MEMORANDUM

DATE: **February 24, 2014**
TO: **Plan Holders**
FROM: **Ronald J. Pritzlaff, Utility Engineer**
RE: **Addendum No. 1**

The Utility has issued Addendum No. 1 to our South Howell Avenue Hydrant Relocation project. You can download a copy of the addendum from our web site at:

The purpose of the addendum is to:

Attachment 2: Backfilling Excavation Detail Drawings

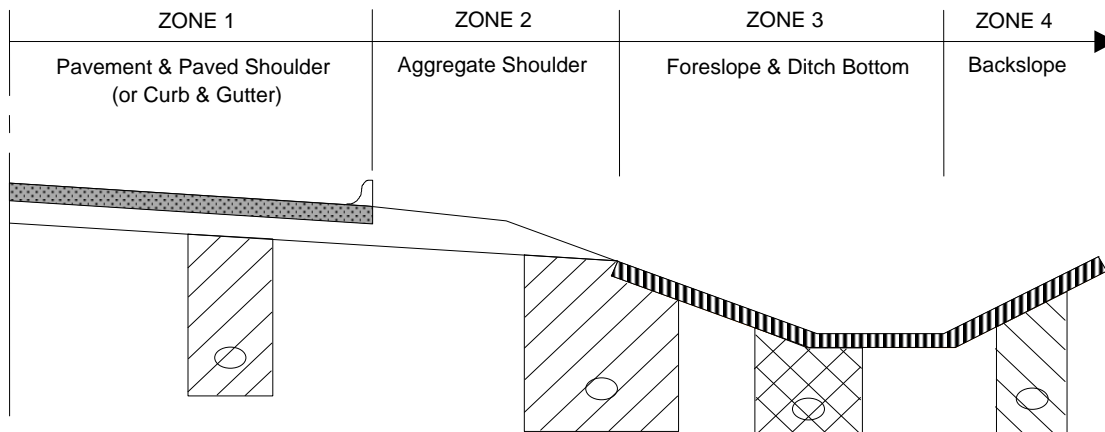
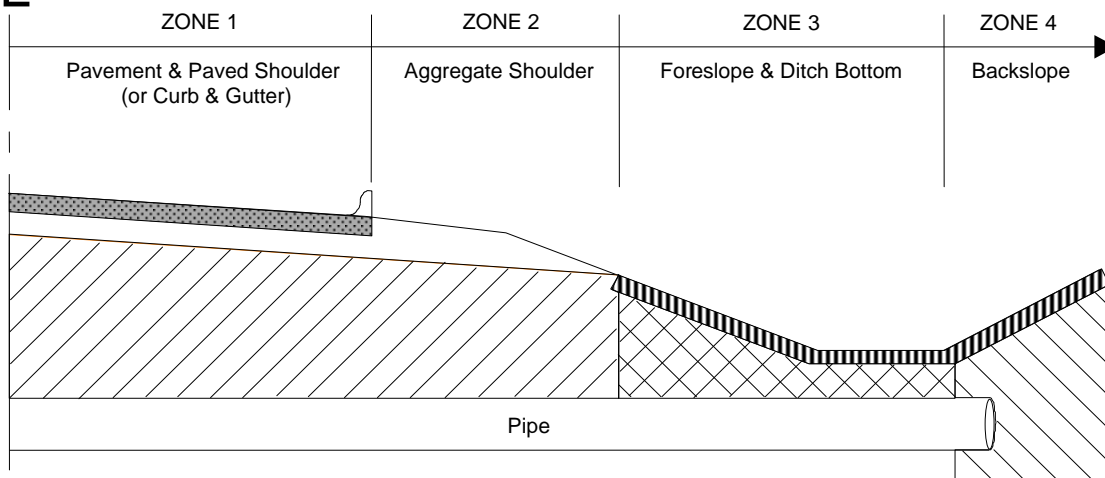
Option 1: The contractor shall backfill using a slurry mix as detailed in Attachment 2 of the Wisconsin Department of Transportation Utility Permit

Option 2: The contractor shall backfill using mechanically compacted granular backfill conforming to Grade 2 of Section 209 of the State Specifications. The contractor shall be responsible for providing the granular backfill and for the testing requirements detailed in the Wisconsin Department of Transportation Utility Permit, Trench Backfill Section.

- 1) Use slurry backfill to replace the excavated material in ZONES 1 and 2.
- 2) If the work area covers BOTH ZONES 2 & 3, use slurry backfill to replace the excavated material.
- 3) Use granular backfill to replace the excavated material in ZONE 3. Granular backfill placement and gradation shall conform to WisDOT's Standard Specifications for Road and Bridge Construction, current edition.
- 4) Place backfill in ZONES 3 & 4 to within 4" of the finished grade to allow for topsoil placement.
- 5) Suitable spoil backfill may be used in ZONE 4 at the discretion of WisDOT.
